CITY PLANNING COMMISSION

APPLICANT Mau, Haidet, Hyde, Schroeder, Inc. 1718 3rd Street #201, Sac., CA 95814
OWNER Church of Jesus Christ of Latter Day Saints, 61 East North Temple St., SLC, UT 841
PLANS BY Mau, Haidet, et al.
FILING DATE 5/19/88 ENVIR. DET. Neg. Dec. 5/27/88 REPORT BY DCS:vf
ASSESSOR'S PCL. NO. 029-0384-007

- APPLICATION:**
- A. Negative Declaration
 - B. Special Permit to develop a 15,000± sq. ft. church facility and a 280± sq. ft. storage building on 3.4± vacant acres in the Standard Single Family-Executive Airport Overlay (R-1, EA-4) zone.
 - C. Variance to exceed the 35' height limit by 15 feet.

LOCATION: Southeast corner of 56th Avenue and Havenhurst Way.

<p>SITE PLAN</p> <p>A-0</p>	<p>THE CHURCH OF JESUS CHRIST OF LATTER-DAY SAINTS</p>	<p>First & Second Wards 56th & Havenhurst Dr. Sacramento, Calif.</p>	<p>DATE: 11/11/88</p>	<p>EXHIBIT C</p>
-----------------------------	--	--	-----------------------	-------------------------

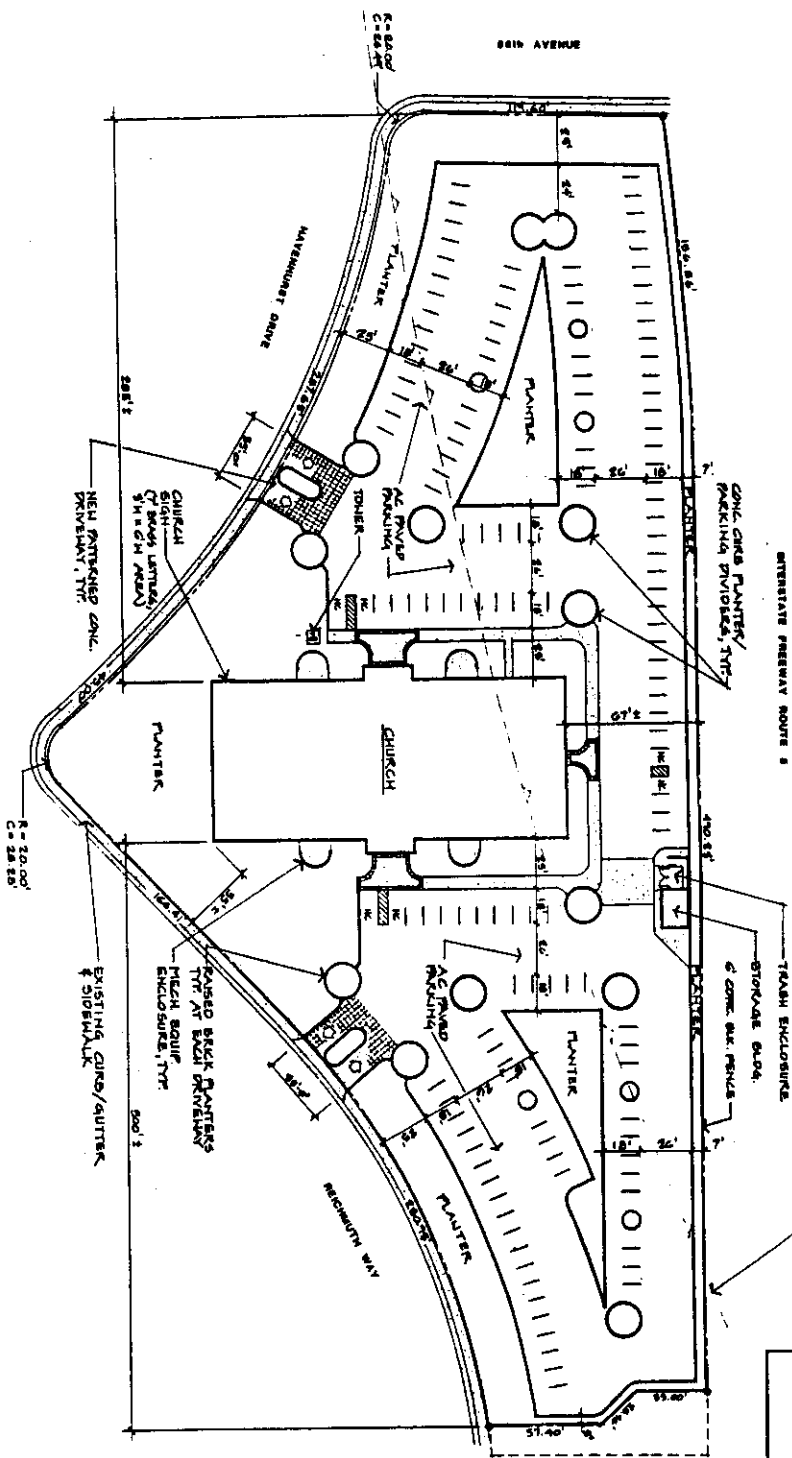
- o The dividers at driveway entrances, as shown, are unacceptable.
- o Repair or replace any substandard improvements.
- o Remove or relocate planters which align with driveway and exits.

EXHIBIT D

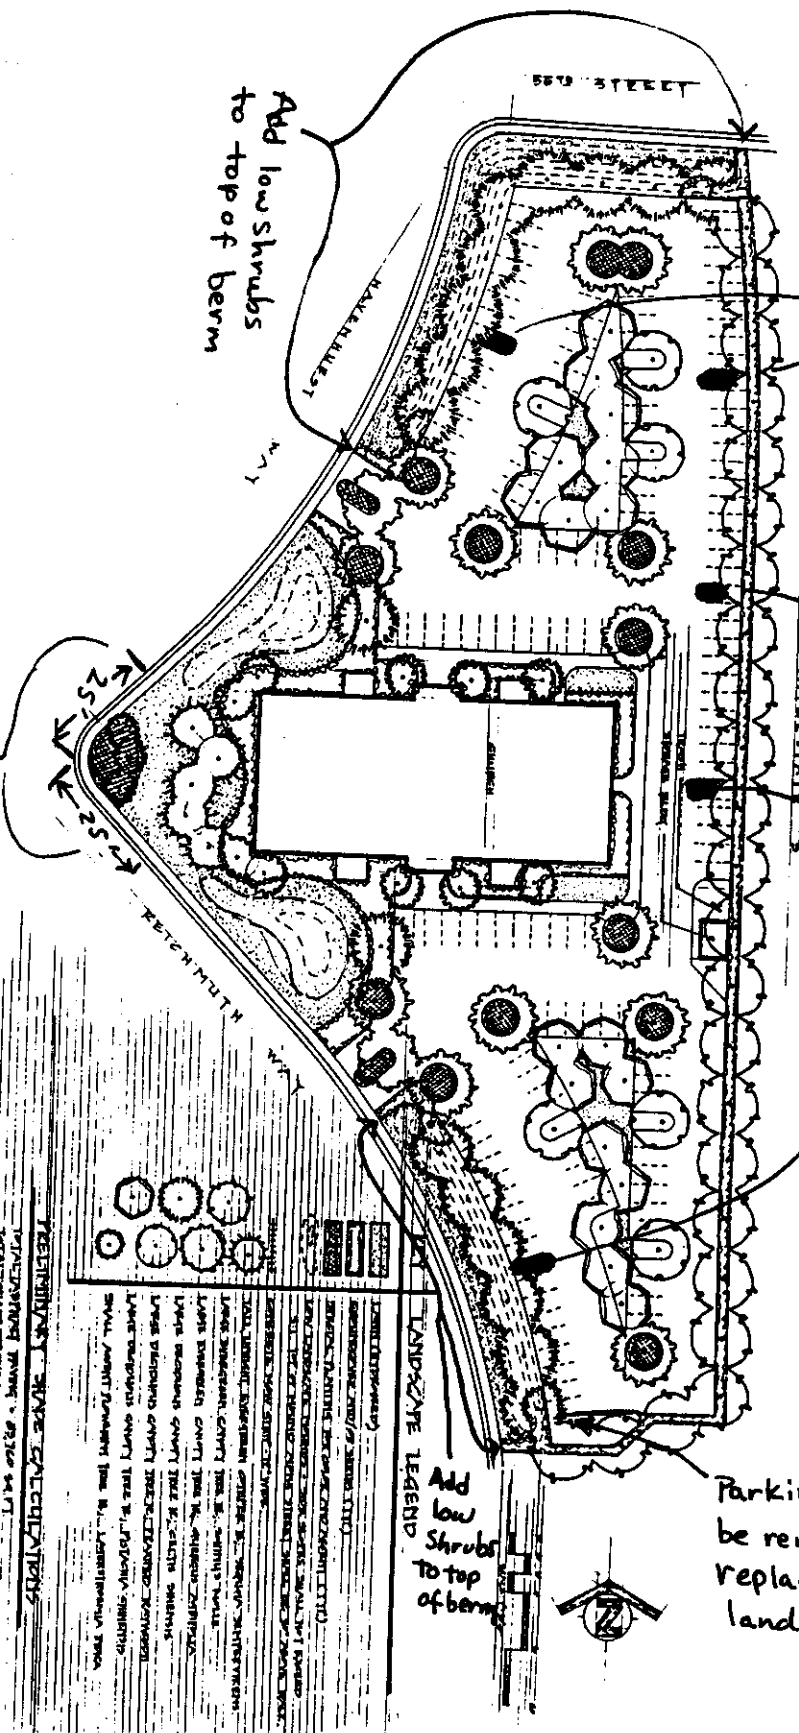
- o additional finger planters shall be added as shown in Exhibit D
- o one parking space on the southerly side of the parking area shall be removed and landscaping provided instead, see Exhibit D.
- o rather than using wheel stops, parking shall be designed to overhang planters by two feet.
- o low shrubs shall be incorporated into 25 ft. bermed areas to help reduce headlight glare on surrounding residential properties.
- o shrubs at the corner of Havenhurst Way and Reichmuth Way shall be maintained at a height of three ft. or lower to allow clear visibility at that intersection.
- o concrete curbing along planter areas shall be poured concrete not extruded.

Shrubs/plantings in this area to be 3 feet or less in height. Add note to reflect this in revised landscape plan

Add low shrubs to top of berm

Additional finger planters

Additional finger planters

Add low shrubs to top of berm

Parking space to be removed and replaced with landscaping

- 1. The landscape plan shall be revised to include:
 - a. additional finger planters as shown in Exhibit D;
 - b. removal of the most southerly parking space as indicated in Exhibit D;

- c. redesign planters to accommodate a two foot vehicle overhang adjacent to parking stalls;
 - d. incorporate low shrubs upon the berms adjacent to Havenhurst Way and Reichmuth Way as indicated in Exhibit D.

- e. a note indicating that the shrubs at the intersection of Havenhurst Way and Reichmuth Way shall be less than three feet in height. (The Building Inspection Division should be contacted to include any additional tree shading requirements which may be added to the revised landscape plan);
